TRANS/WP.29/GRRF/2003/8
22 November 2002

PROPOSAL FOR DRAFT AMENDMENTS TO REGULATION No. 13
(Braking)

Transmitted by the Expert from Germany

Utilization curves f1, f2 of inertia braked full trailers

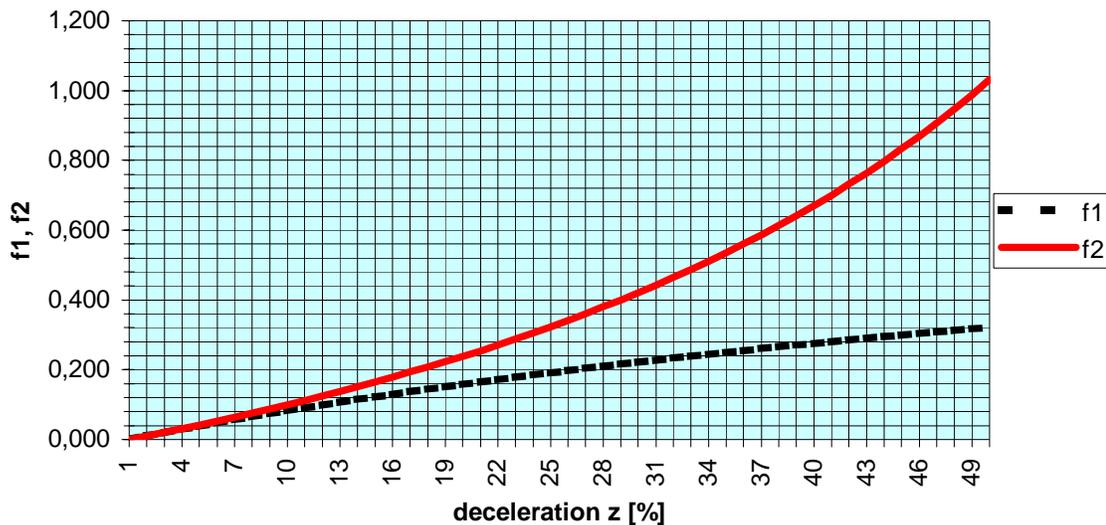
The figure below shows adhesion utilization curves calculated for a fifth-wheel trailer with symmetrical brake force distribution.

Trailer data: $P = 3500$ kg (per axle 1750 kg) - $E = 2.80$ m - $h_R = 1.5$ m.

The brake force distribution shown in the figure below, being typical for many full trailers currently on the roads which are braked by an overrun system, the adhesion utilization curve of the rear axle is **above** that of the front axle over the whole deceleration range.

If, for assessment purposes, one refers to the fundamental requirement of annex 10, "for all states of load of the vehicle, the adhesion utilization curve of the rear axle shall not be situated above that for the front axle", it will certainly not be possible to describe the brake force distribution as "appropriate", if this fundamental requirement is **not fulfilled for any state of load and for any deceleration**.

"5.3. For full trailers with inertia (overrun) braking system

5.3.1. The requirements according to paragraph 5.1.1. apply also for full trailers with inertia (overrun) braking system.

5.3.2. For full trailers with inertia (overrun) braking system and with more than two axles the requirements according to paragraph 5.1.2. apply.

5.3.3. For the calculation to verify the compliance with the provisions of paragraph 5.1.1.3. the influence of the permissible drawbar force D^* (paragraph 9.3.1. annex 12) can be ignored."
